UNITED STATES PATENT AND TRADEMARK OFFICE

APPLICATION NO.	FILING DATE	FIRST NAMED INVENTOR	ATTORNEY DOCKET NO.	CONFIRMATION NO.
10/501,537	10/22/2004	Istvan Knoll	742111-159	6354
25570 7590 07/06/2007 ROBERTS, MLOTKOWSKI & HOBBS P. O. BOX 10064 MCLEAN, VA 22102-8064			EXAMINER ALI, MOHAMMAD M	
			ART UNIT 3744	PAPER NUMBER
			MAIL DATE 07/06/2007	DELIVERY MODE PAPER

Office Action Summary

DETAILED ACTION

**FIG. 6**

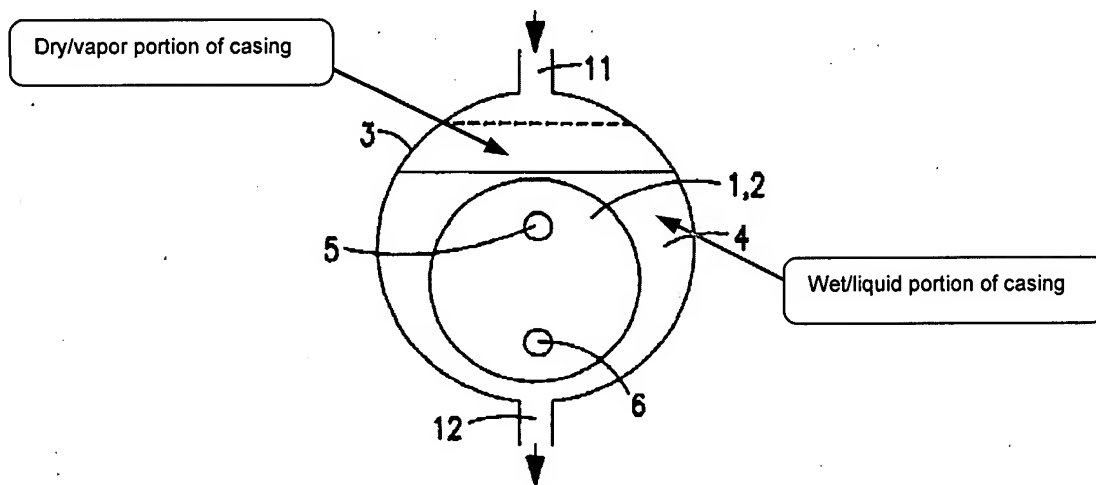
Regarding claim 1, Lampinen et al. disclose a submerged (as seen in the illustration of Figure 6 below) evaporator (1, 2 – plate heat exchangers) contained in a casing (3 – shell) and including at least one integrated plate heat exchanger (heat exchangers [1, 2] are integrated with respect to the connectors [5, 6, 7, 8]; Figure 6), where the integrated plate heat exchanger has at least one inlet connection (5, 7 – connectors) and at least one outlet connection (6, 8 – connectors) for a secondary refrigerant (as seen in Figure 6), where the plate heat exchanger is disposed at the bottom of the casing (as seen in Figure 6), where a primary refrigerant (water) may flow around the plate heat exchanger (see col. 6, lines 24-34, 65-67) and a secondary refrigerant may flow through the plate heat exchanger (see col. 6, lines 43-50), and where the uppermost part of the casing is

used as a liquid separator (as seen in Figure 6), wherein the integrated plate heat exchanger is integrated with the evaporator (as seen in Figure 7) and made with an outer contour that substantially follows the lower contour of the casing and the liquid level of the primary refrigerant (as seen in Figures 6, 7).

Regarding claim 2, Lampinen et al. disclose the longitudinal sides of the plate heat exchanger are closed for inflow or outflow of the primary refrigerant between the plates of the plate heat exchanger (as seen in Figures 6, 7), and wherein the bottom of the plate heat exchanger there is provided at least one opening through which the primary refrigerant flows in between the plates of the plate heat exchanger (as seen in Figure 7).

Regarding claim 8, Lampinen et al. disclose being adapted in order that secondary refrigerant may flow to and from the plate heat exchanger via one connection (7 – connector) at the bottom of the plates and one connection (8 – connector) at the upper edge of the plates, respectively (as seen in Figures 6, 7).

Regarding claim 9, Lampinen et al. disclose being adapted in order that secondary refrigerant may flow to and from the plate heat exchanger via one connection at the bottom of the plates (6 – connector) and two connections (5, 8 – connectors) at the upper edge of the plates, respectively (as seen in Figures 6, 7).

Regarding claim 10, Lampinen et al. disclose the casing contains a suction manifold (21 – dispersing plate) disposed in the "dry" part (as seen in the illustration of Figure 6 above) of the casing and extending in longitudinal direction of the evaporator with a length substantially corresponding to the length of the plate heat exchanger (as seen in Figure 6).
